### TECHNICAL EVALUATION REPORT

## REVIEW OF LICENSEES' RESOLUTION OF OUTSTANDING ISSUES FROM NRC EQUIPMENT ENVIRONMENTAL QUALIFICATION SAFETY EVALUATION REPORTS (F-11 AND B-60)

ROCHESTER GAS AND ELECTRIC CORPORATION  
R. E. GINNA STATION

NRC DOCKET NO. 50-244

Figure A-4. Containment Temperature Steam Break HZP 1/2 Spray System

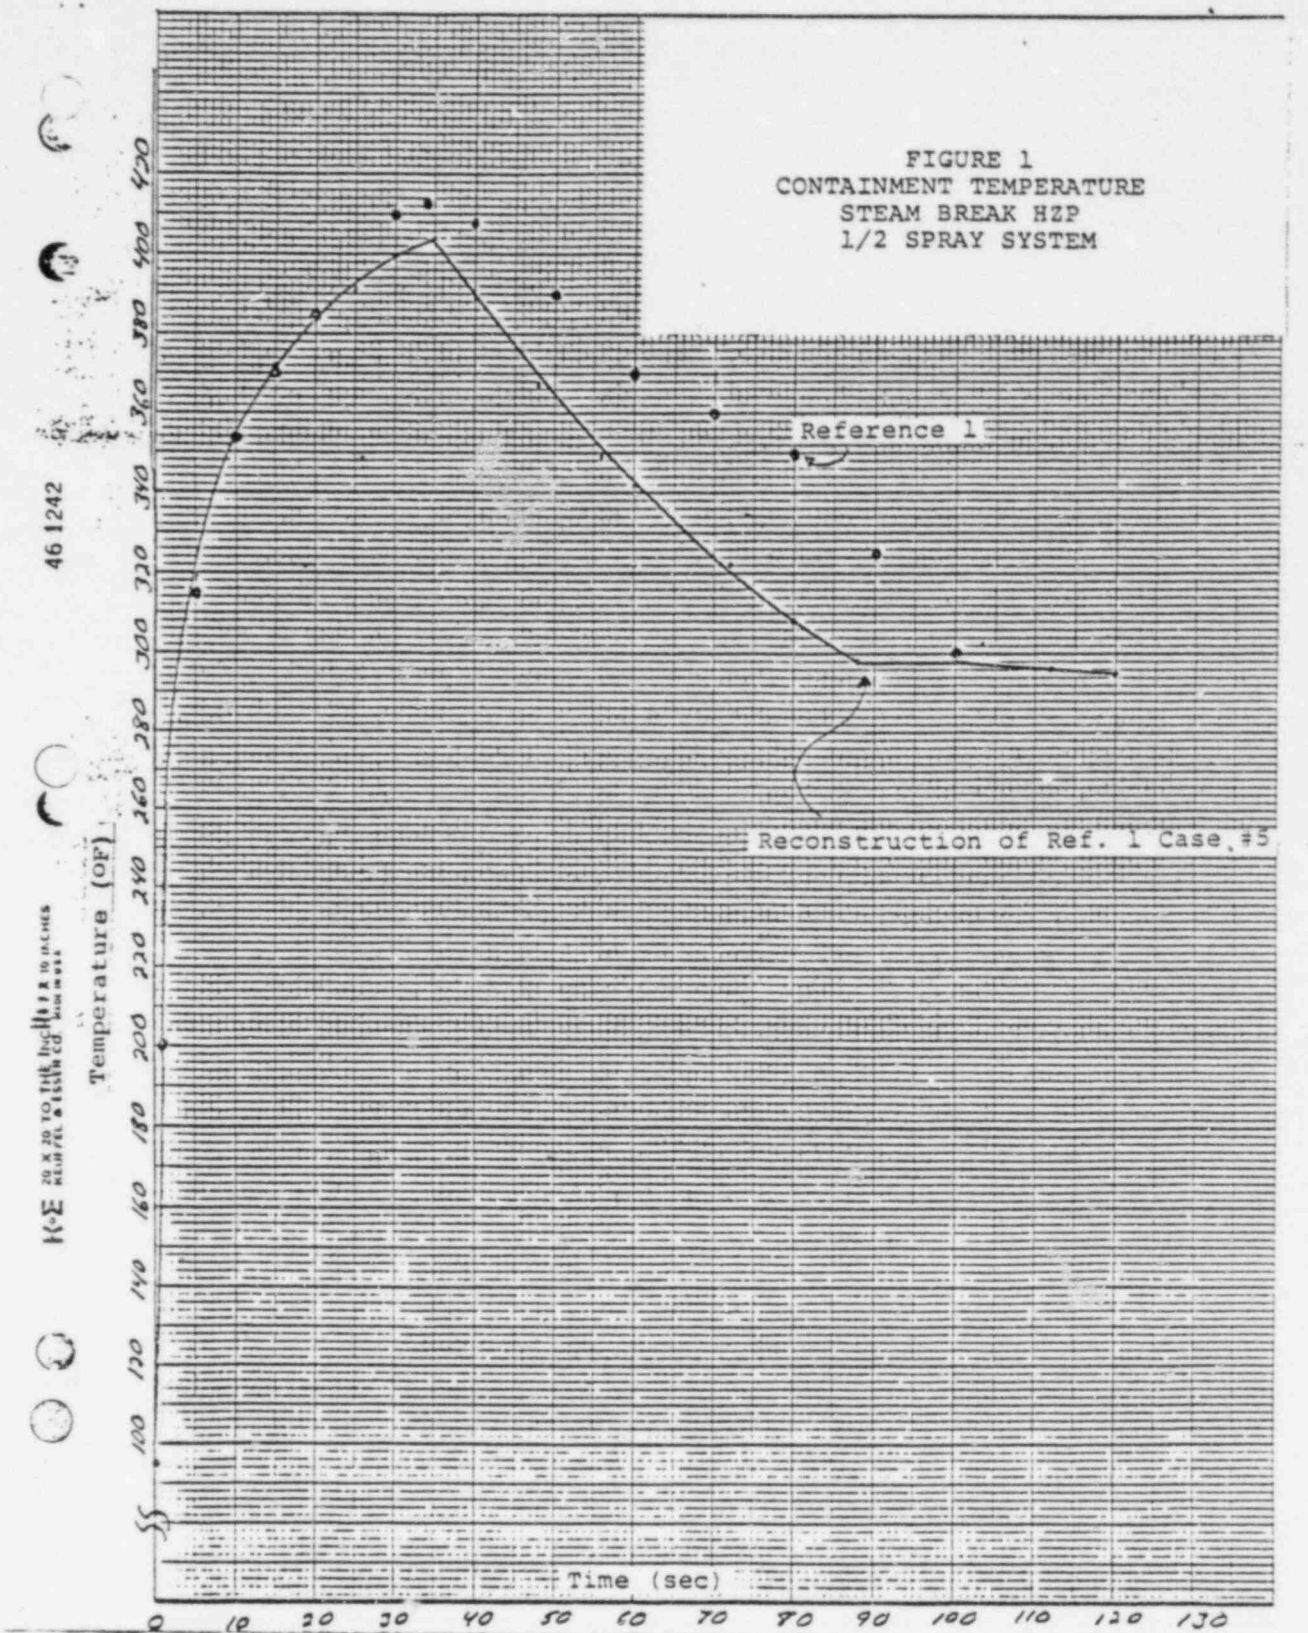
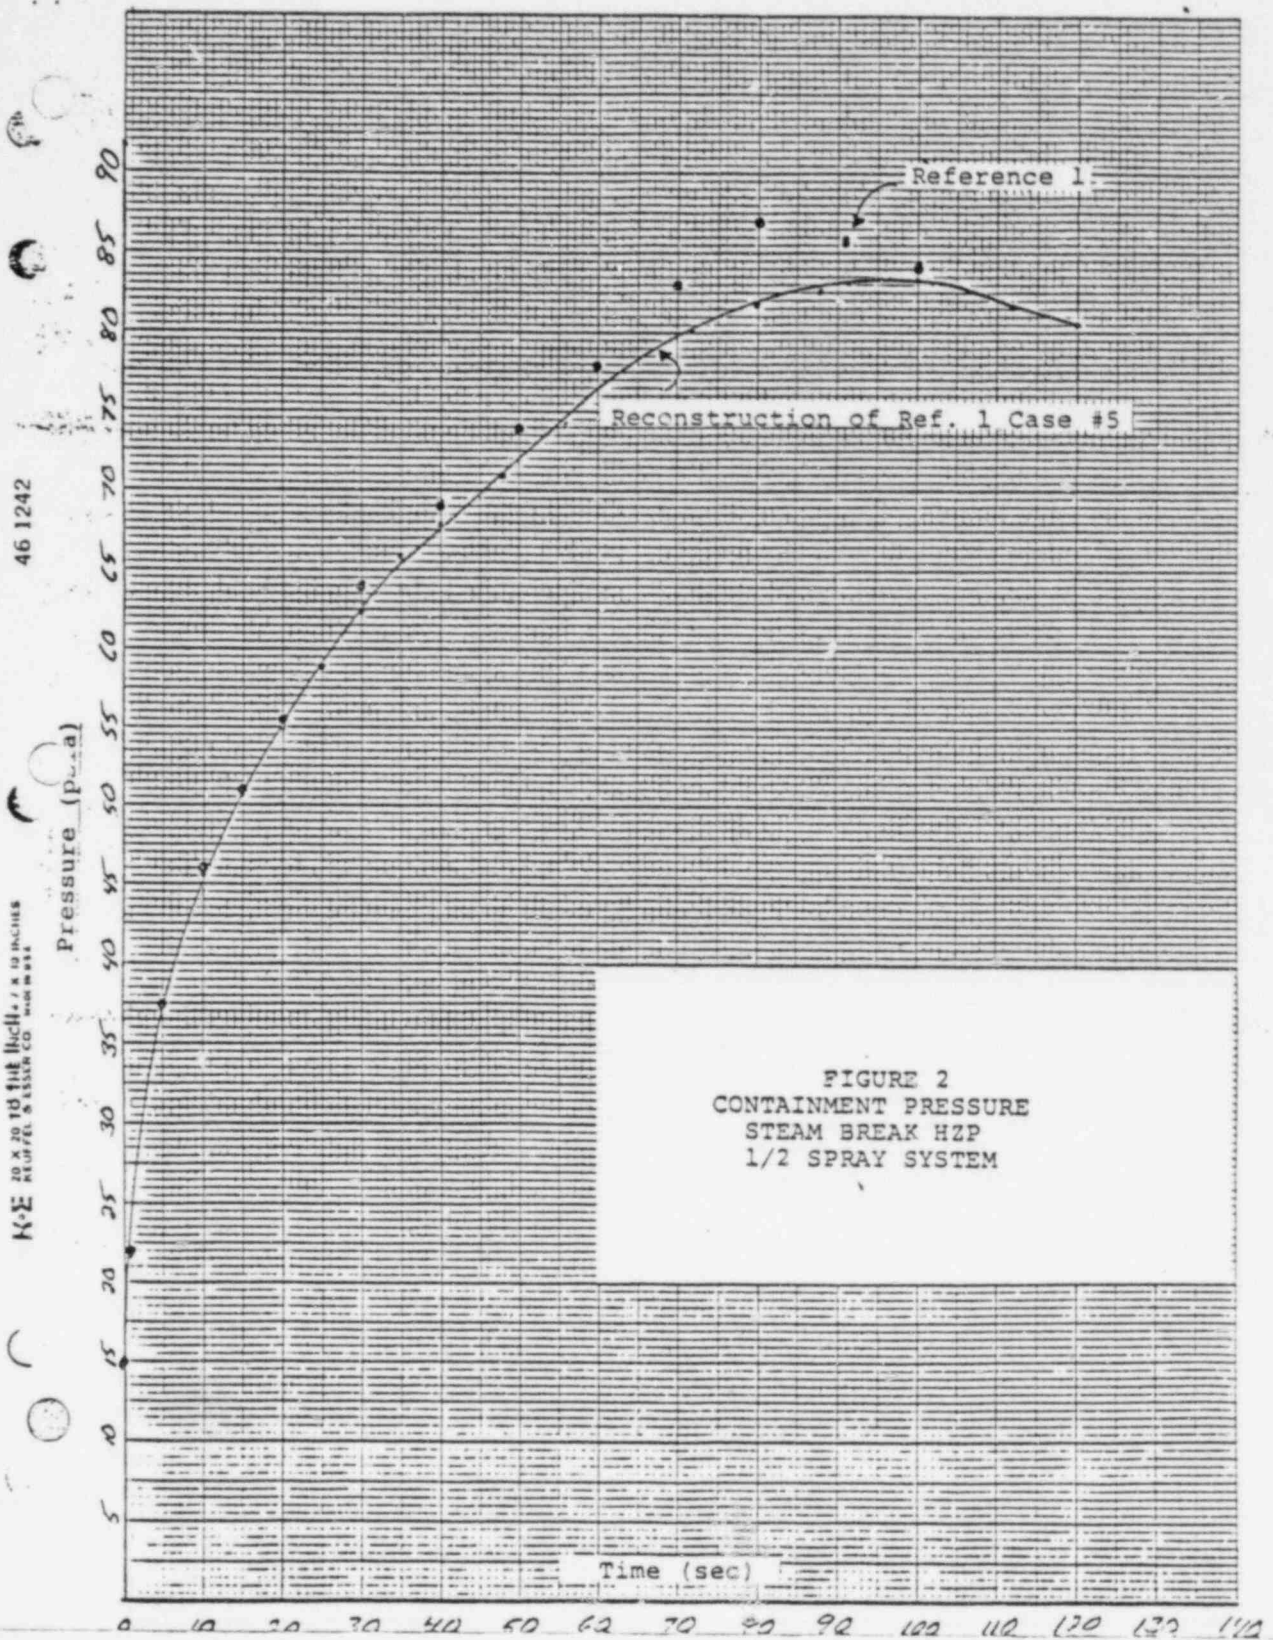
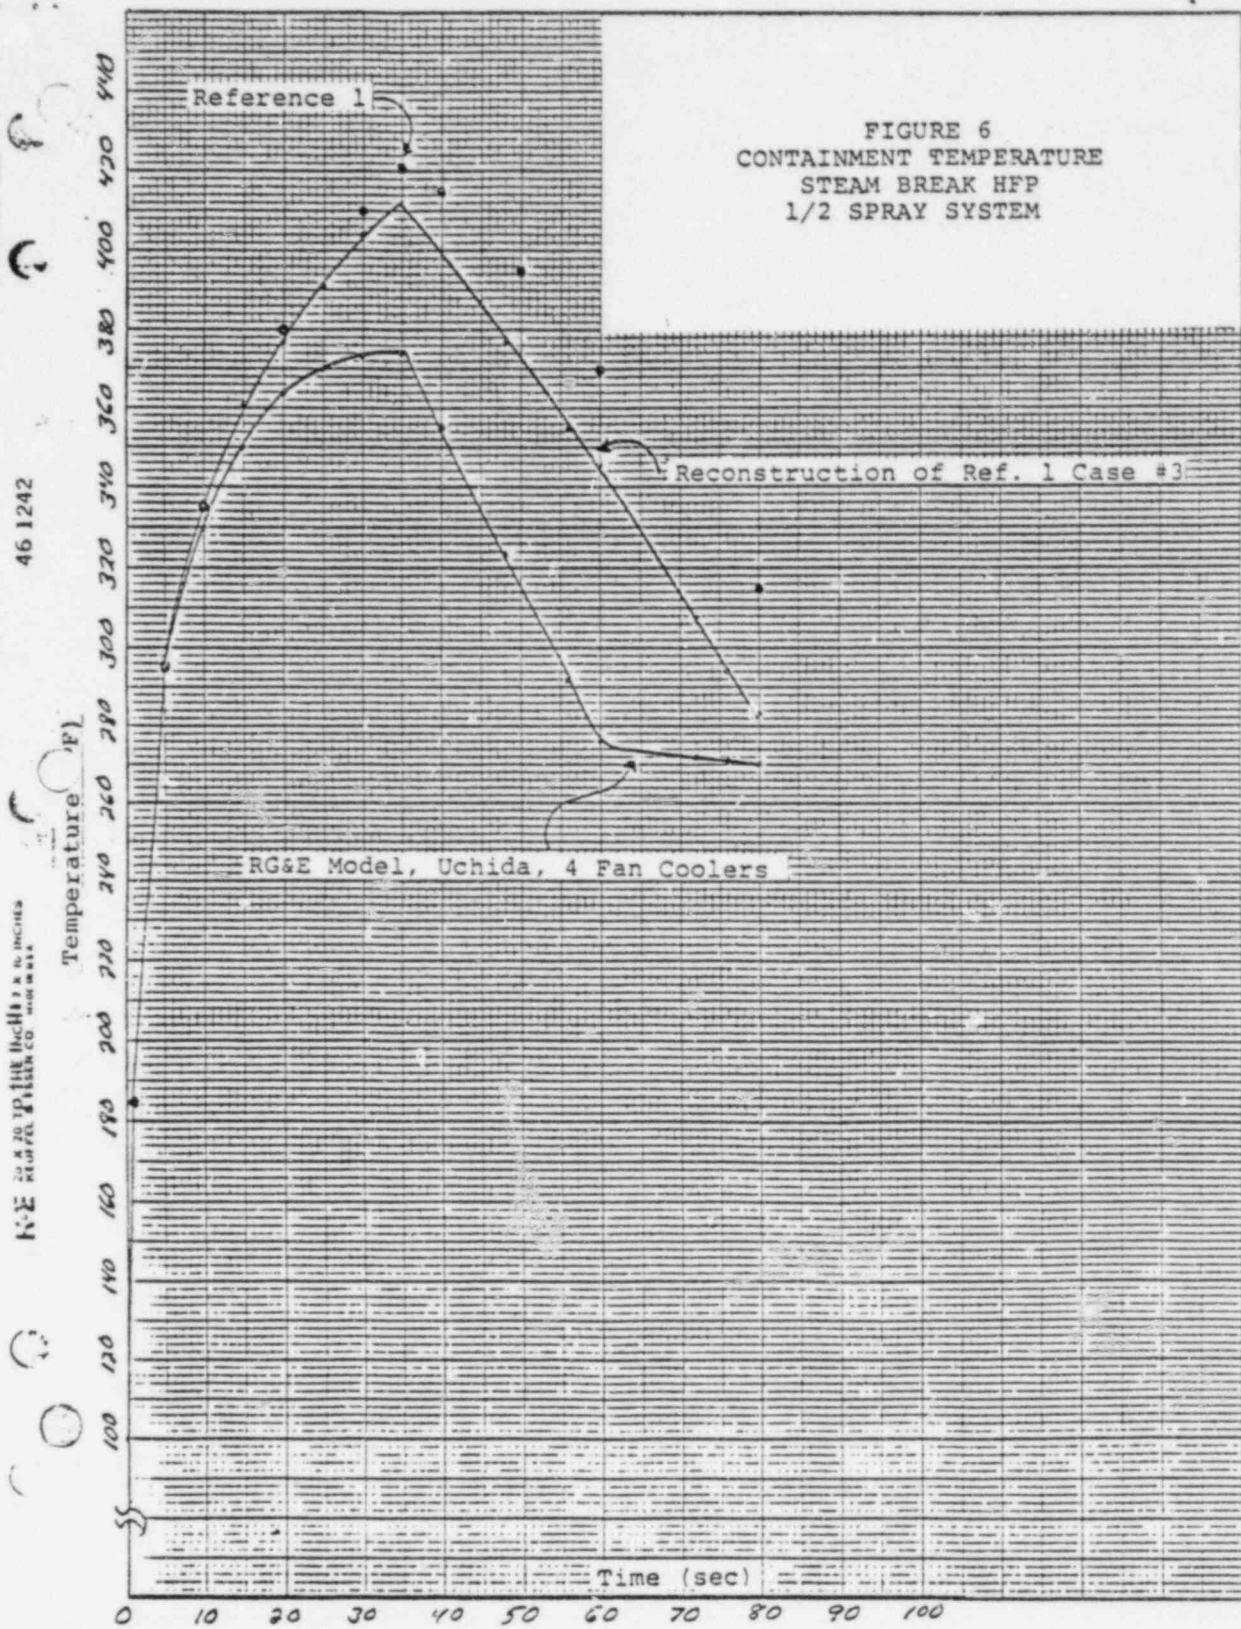
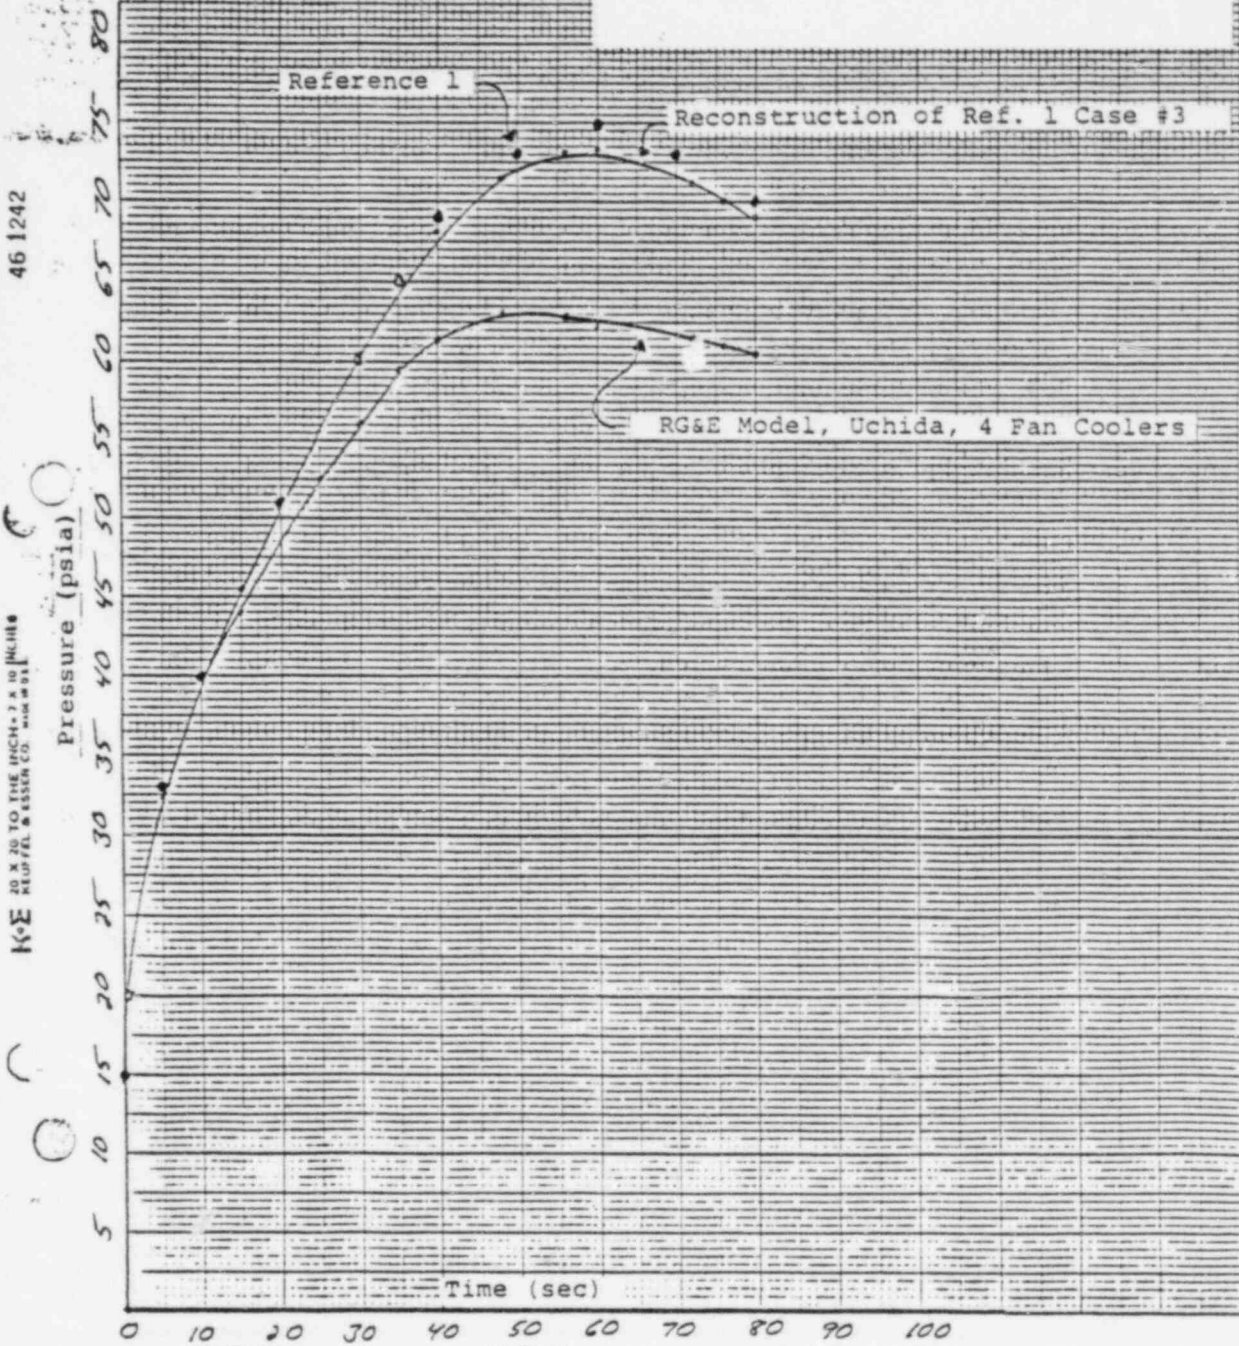
In Reference 74, the Licensee transmitted to the NRC an updated evaluation of the pressure and temperature conditions which would result from a LOCA or steam line break inside containment. The Licensee recommended that the LOCA temperature be revised to show a value of 250°F between 10,000 seconds and 20,000 seconds rather than the values shown on Figure A-2. Beyond 20,000 seconds, the Licensee recommended a temperature of less than 100°F. The Licensee also provided its results of the main steam line break analysis inside containment [74]; Figures A-4, A-5, A-6, and A-7 show the results of the analysis contained in Reference 74. The Licensee stated the following:
